Re: Initial Submission Review – Murphy Creek GDP Amendment No 3 – GDP Amendment and Street Vacation
Application Number: **DA-1250-57**
Case Numbers: **1995 2002 11; 2022 8007 00**

First Submission Review

MURPHY CREEK GDP AMENDMENT No. 3

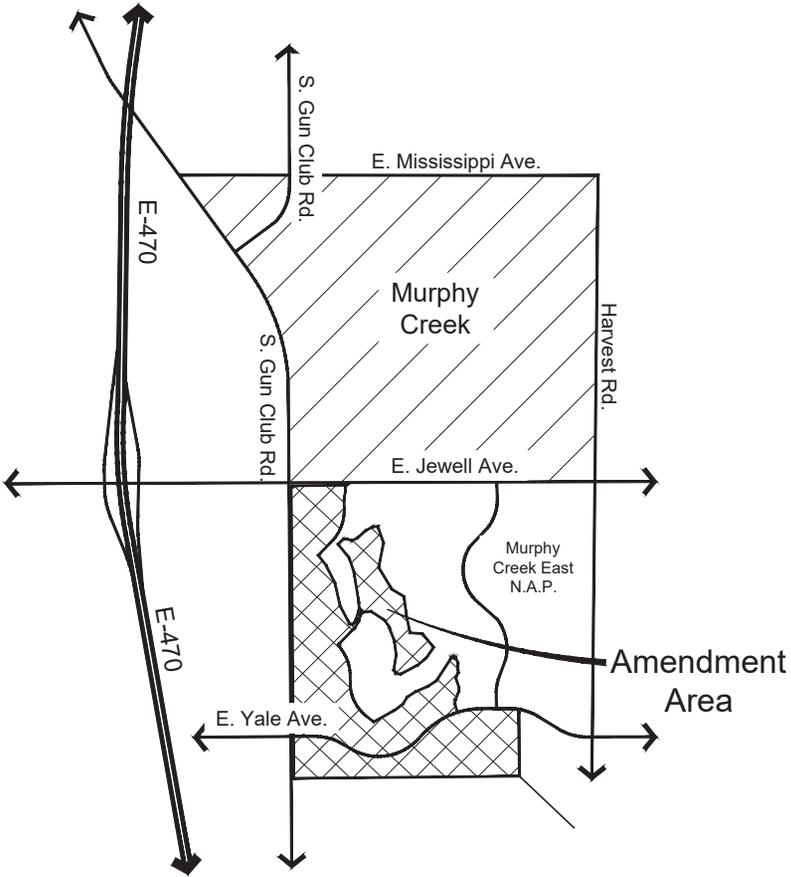
Other accesses shown to Hwy 30 include multiple full movement accesses and the north access is shown as signalized. Full movement access per the State Highway Access Code is half mile spacing. Signalized accesses shall be coordinated with CDOT Traffic and meet appropriate signal warrants.

A meeting with the Murphy Creek team took place on October 28, 2022, where they were made aware of the development on the West side of SH 30 (Aspen Business Park) and that CDOT will be permitting access to Yale Ave. in the original location.

Murphy Creek General Development Plan Amendment No. 3

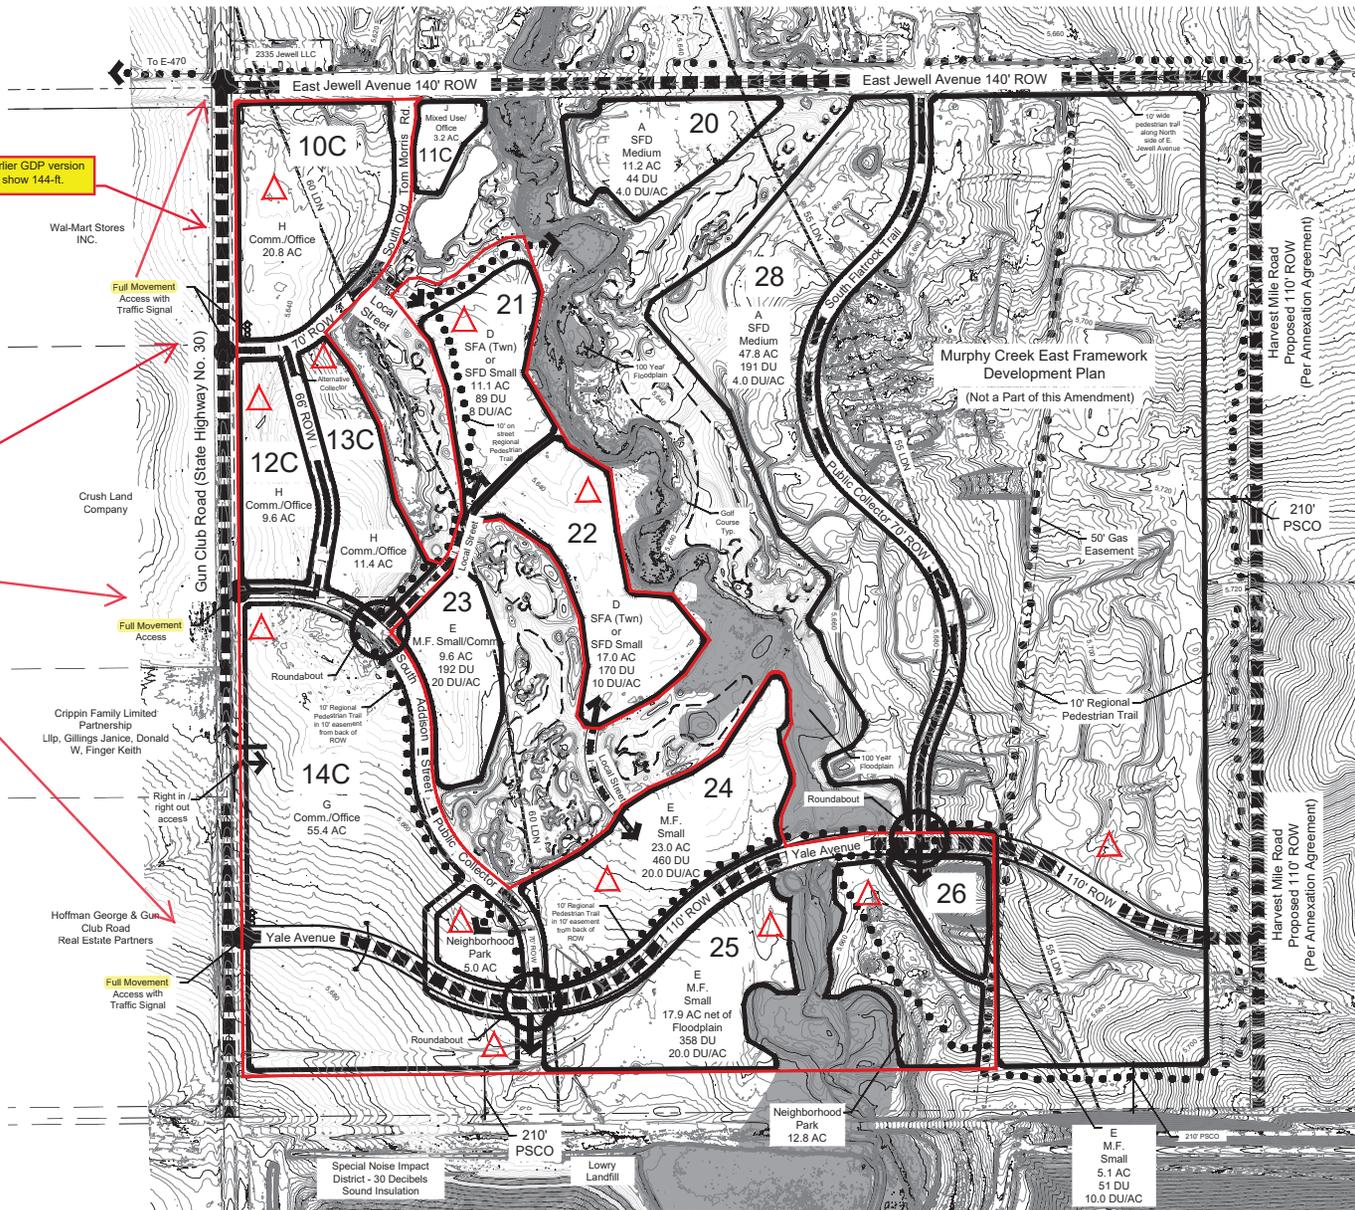
Add the Aerial RoW. Earlier GDP version shows 140-ft, other plans show 144-ft.

Other properties along west side of Gun Club have advanced their planning to ID full movement access points. Show how all full movement access points alignments align with west side.

Amendment No. 3 Murphy Creek Aurora, Colorado

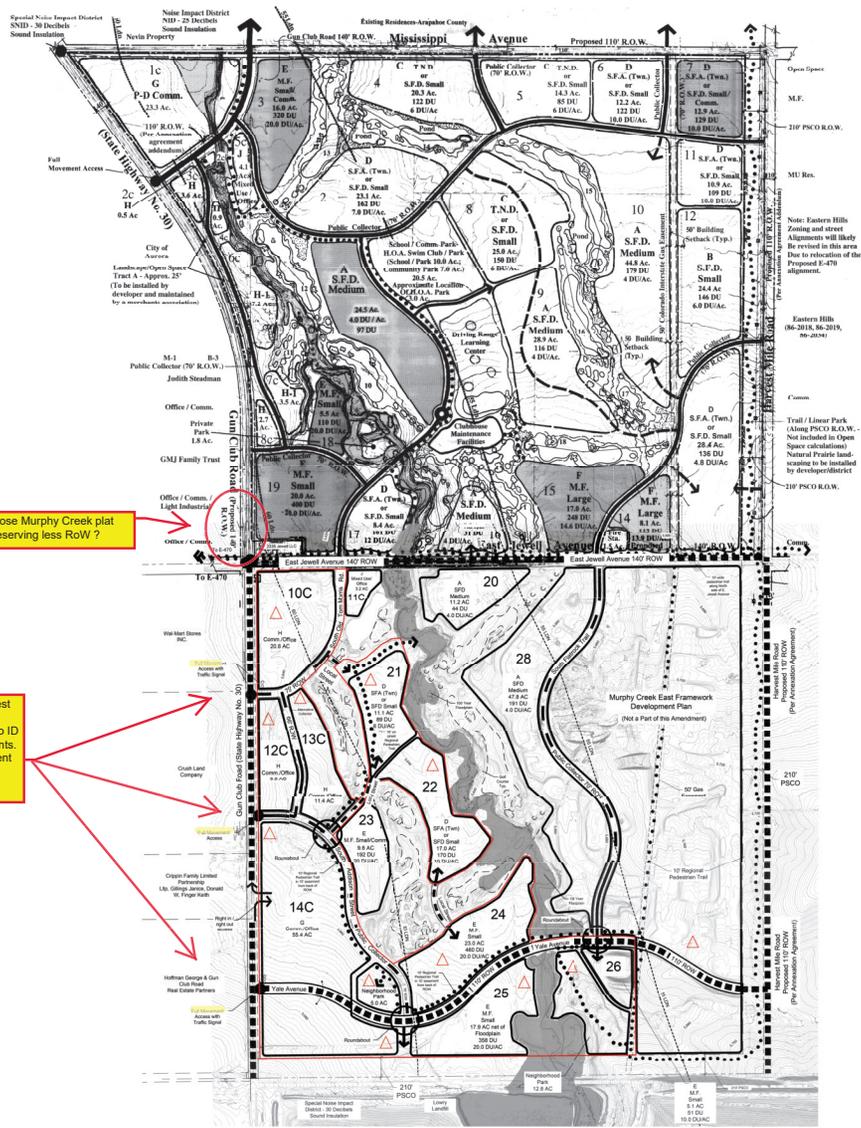
Why is Prose Murphy Creek plat offering/reserving less RoW ?

Other properties along west side of Gun Club have advanced their planning to ID full movement access points. Show how all full movement access points alignments align with west side.
